Work Order ID 60471

Item Name: Basket Hoop

DESIGN #	DRAWN BY CP	DART AEROSPACE LTD HAWKESBURY, ONTARIO, CANADA	
CHECKED #	APPROVED #	DRAWING NO. D3166	REV. A SHEET 1 OF 1
DATE 02.07.10		TITLE BASKET HOOP	SCALE NTS
A	02.07.10	NEW ISSUE	
A1	04.04.08	38+/-1 WAS 36.0

DRAWING NO. D3166	TITLE BASKET HOOP	REV A1	DART AEROSPACE LTD ENGINEERING ORDER		D.E.O. NO. D3166-A-2	SHEET NO. 1 OF 1	SCALE NTS
DRAWN AJS	CHECKED <i>[Signature]</i>	MFG. APPR. <i>[Signature]</i>	APPROVED <i>[Signature]</i>		DE APPR. <i>[Signature]</i>		
DATE 08.12.11	DATE 08.12.15	DATE 08/12/15	DATE 08/12/16		DATE 08.12.16

D3166-1 BASKET HOOP

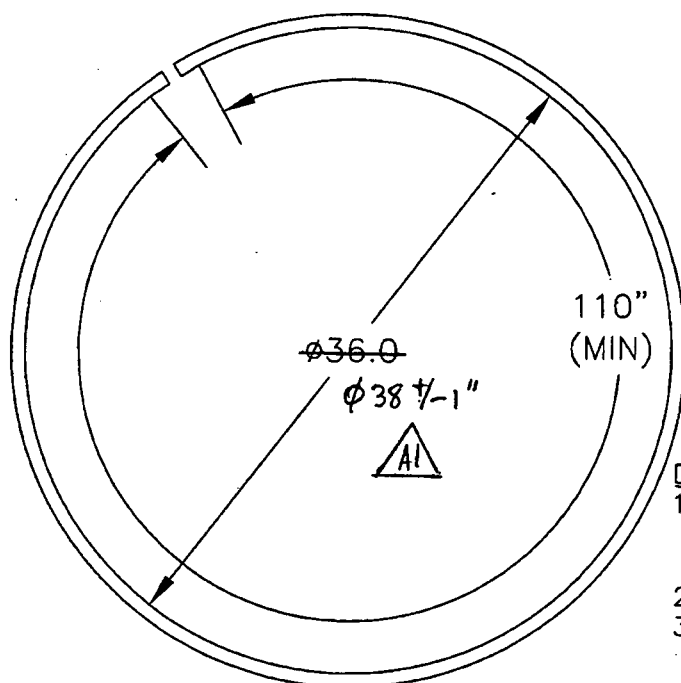
1) MODIFY MATERIAL NOTE FOR D3166-1 AS SHOWN:

WAS:

1) MATERIAL: AISI 304/316 SS SQUARE TUBING,
0.75" x 0.75" x 0.063 WALL, 60.00" LONG
(REF DART SPEC. M304TS0.750W.063)

2) MODIFY MATERIAL NOTE FOR D3166-3 AS SHOWN:

WAS:

1) MATERIAL: AISI 304/316 SS SQUARE TUBING,
0.75" x 0.75" x 0.063 WALL, 120.00" LONG
(REF DART SPEC. M304TS0.750W.063)

REASON: SEE PAR 08-005

IS:

1) MATERIAL: AISI 304/316 SS, 3/4 X 3/4 X 0.065 WALL SQUARE TUBING,
60.00" LONG
REF. DART SPEC M304TS0.750W.065

IS:

1) MATERIAL: AISI 304/316 SS, 3/4 X 3/4 X 0.065 WALL SQUARE TUBING,
120.00" LONG
REF. DART SPEC M304TS0.750W.065
